ADDENDUM 02

DATE 02.10.23
 PROJECT NO. 2154
 PROJECT WEST FIELD SR. SEMINARY
 FROM STUDIO 333 ARCHITECTS

This Addendum consists of 2 pages and the attached Drawing Sheets CE1.1 SITE PLAN, CE3.1 UTILITY PLAN, A1.11 1ST LEVEL REFLECTED CEILING PLAN, A1.31 FINISH SCHEDULE & LEGEND, EE603 SCHEDULES and EL101 1ST LEVEL LIGHTING PLAN, SO.02 STRUCTURAL NOTES.

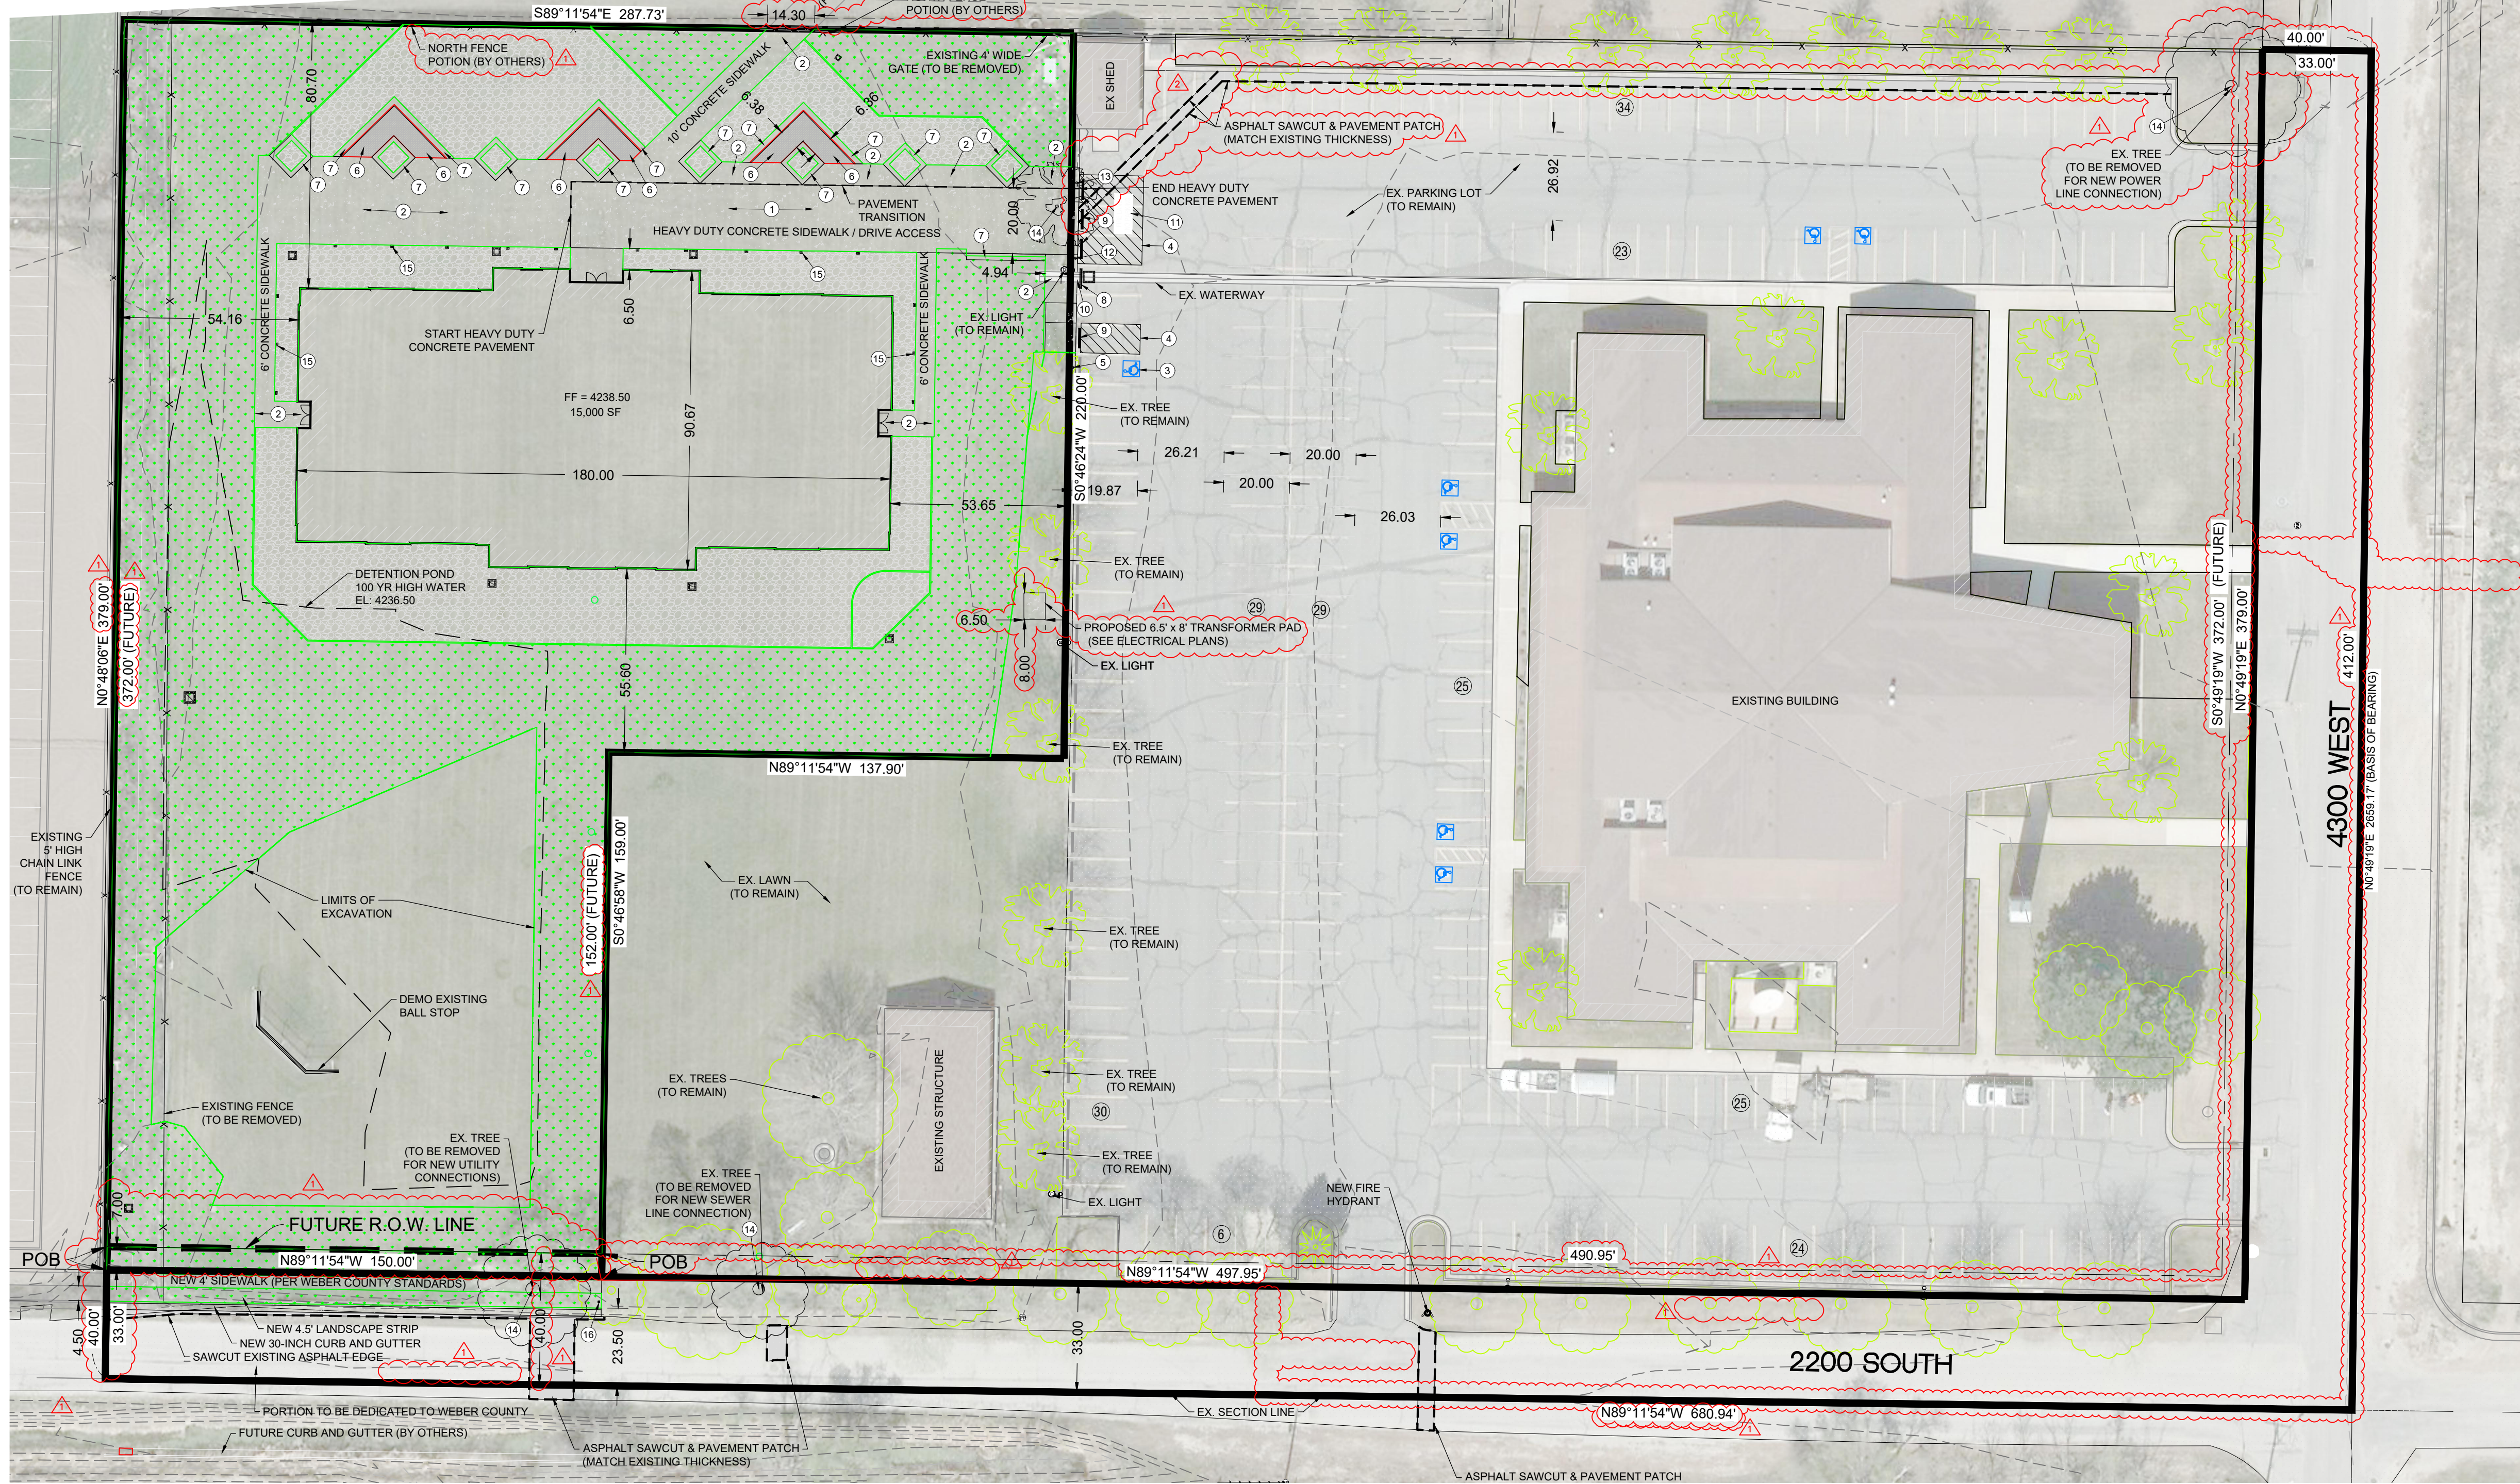
- a. Near the bottom left corner of the sheet, the existing 4-inch gas line (which was recently added to Dominion Energy existing mapping), is shown.
 - b. The location of the proposed Gas line service has also been added at location suggested by Dominion Energy.

- c. Power line going to the new building is now located on the south side of the building (to match what electrical engineer has on their plans).
 - d. A 10' wide RMP utility easement was also added centered on the new proposed power line.

- e. The power conduit routing was adjusted as was previously mentioned on the site plan (by the existing shed area). 5' radius sweeps are shown for the power conduit (to avoid bends).

- f. The connection to the existing was corrected to read, "Existing Ph 3 Ground Sleeve" per Rocky Mountain Power provided correction.
 - g. "Existing power line (approximate location) field verify as needed" note, and related existing power based on RMP exiting utility mapping was added, along with existing utilities on the north portion of the church, near the proposed trenching area was updated to show more accurately based on existing mapping.

- h. Existing gas service going to the church was added on the south side of the existing church building (for reference purposes).
 - 3. Sheet A1.11 1ST LEVEL REFLECTED CEILING PLAN:

CE1.1

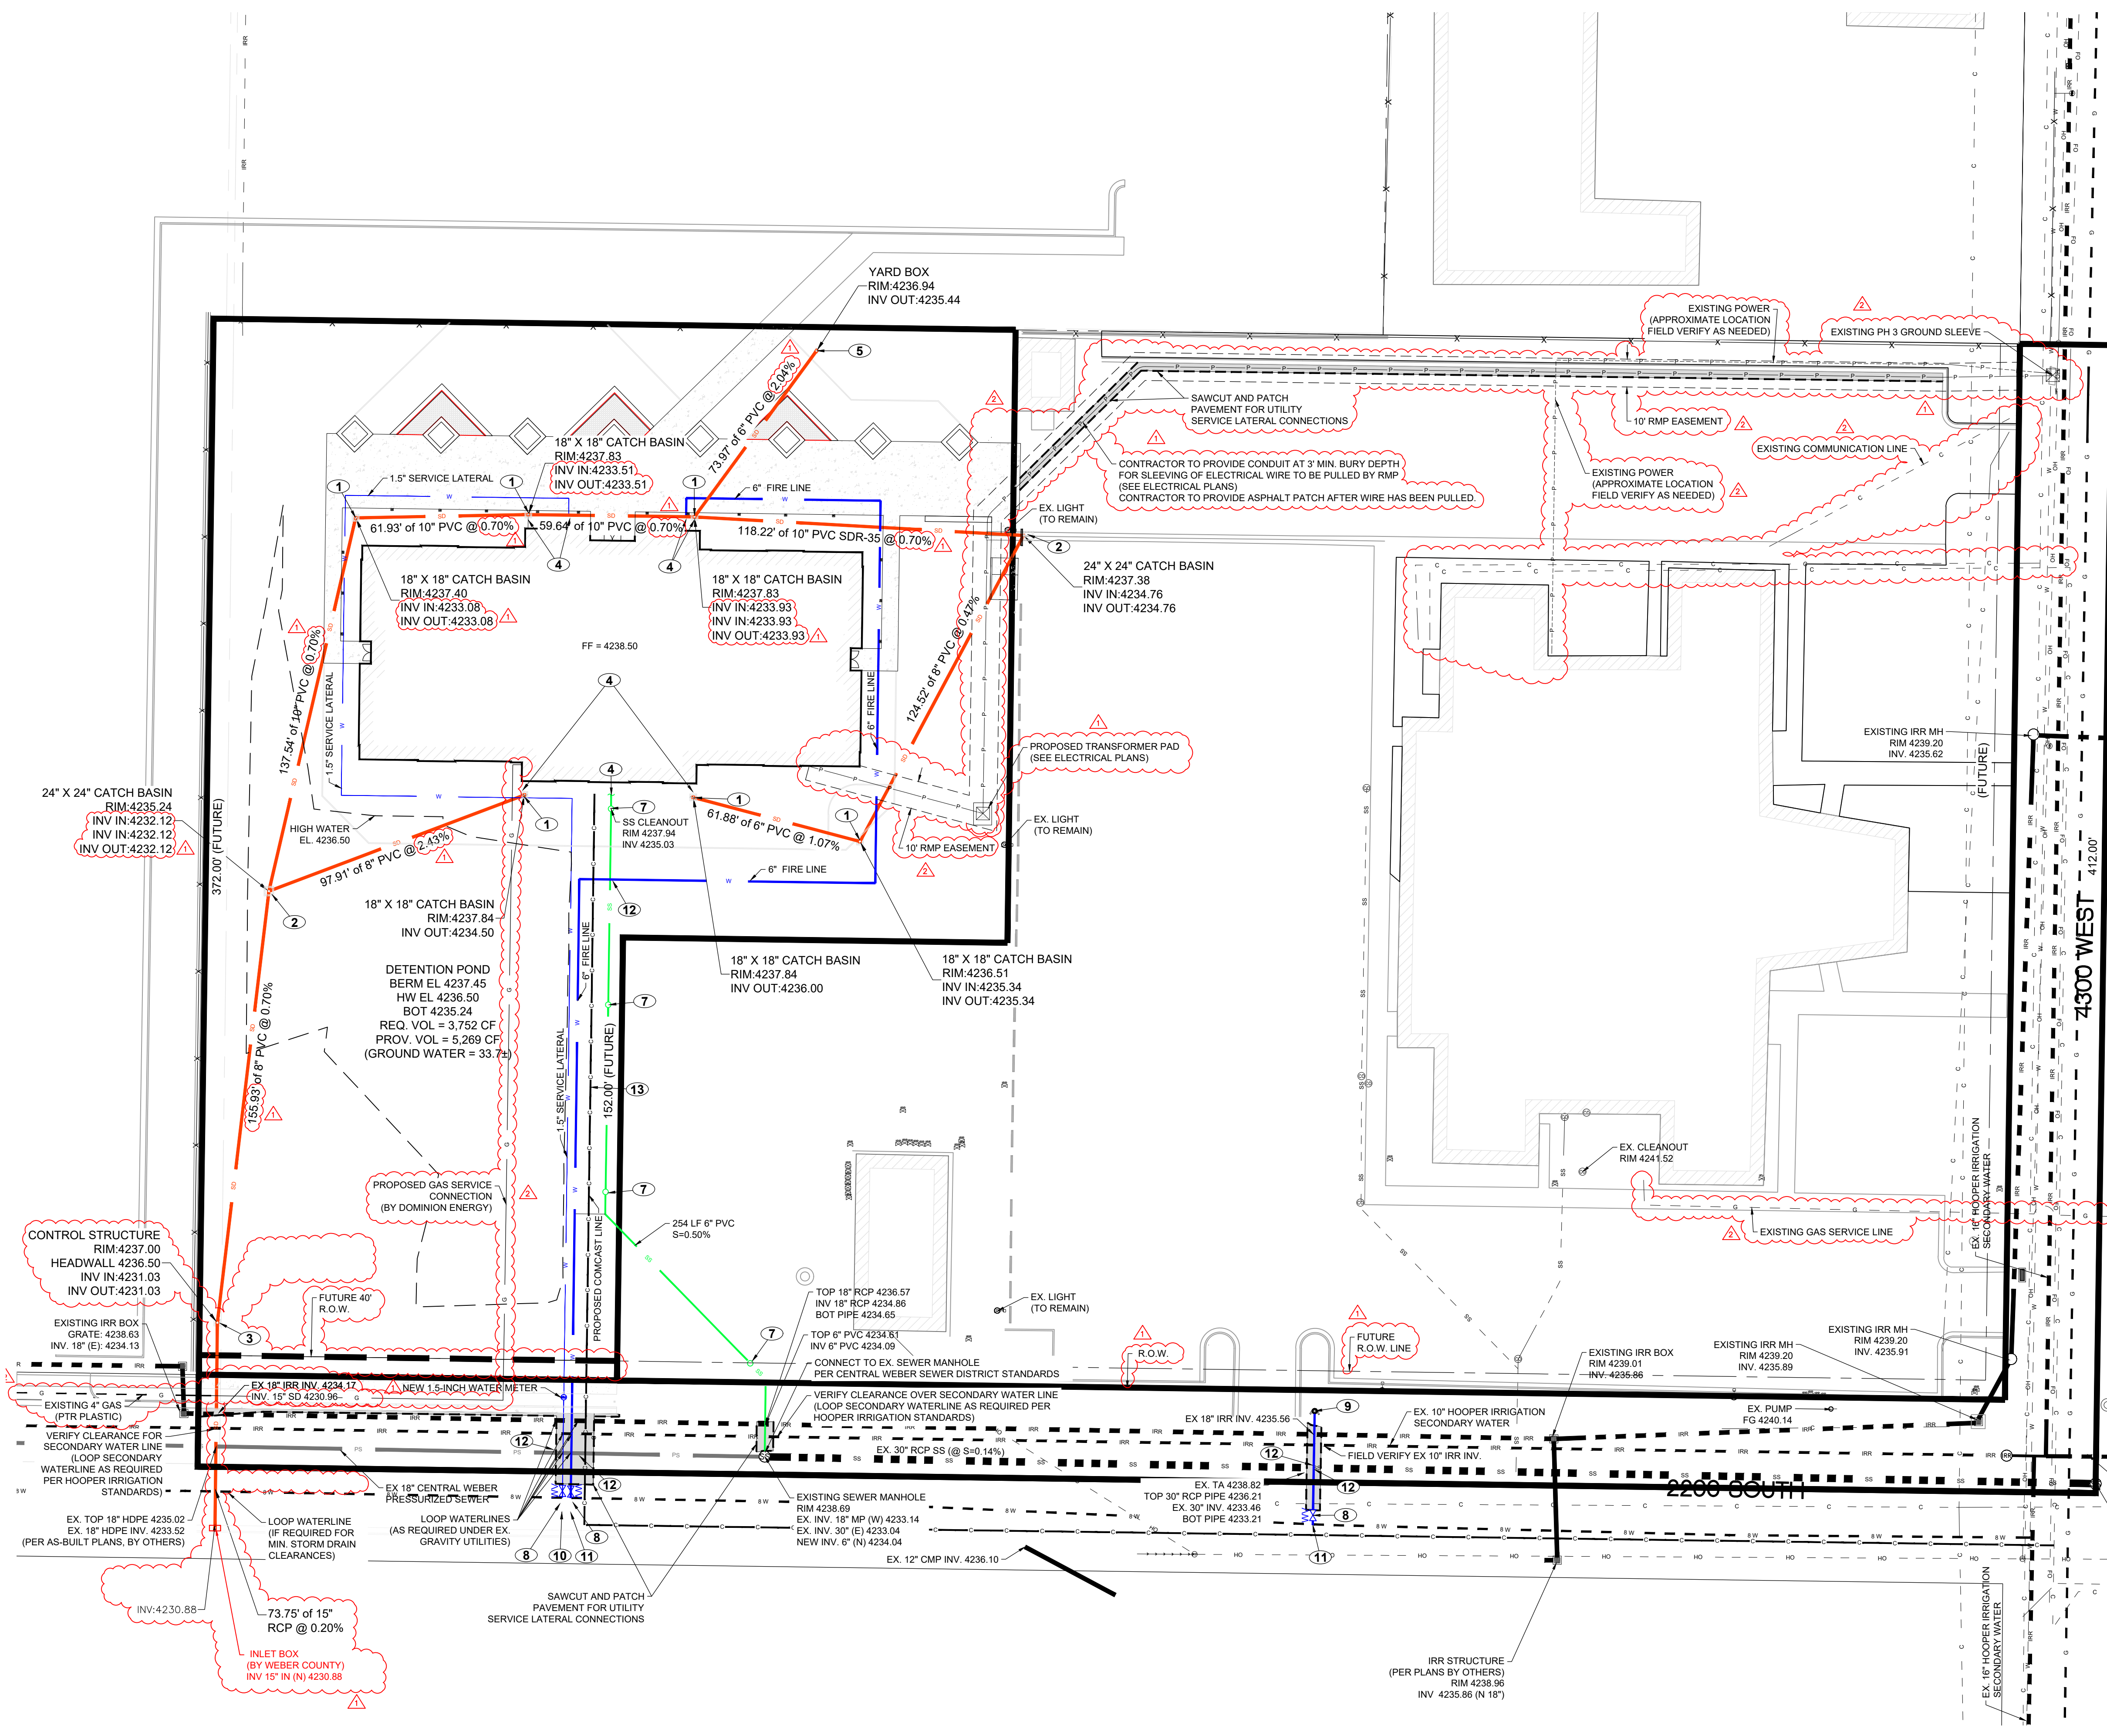
- A. Changes to drawings:
 - 1. Sheet CE1.1 SITE PLAN:
 - a. The conduit routing for saw-cutting was adjusted to be on an angle by the existing shed.
 - 2. Sheet CE3.1 UTILITY PLAN:
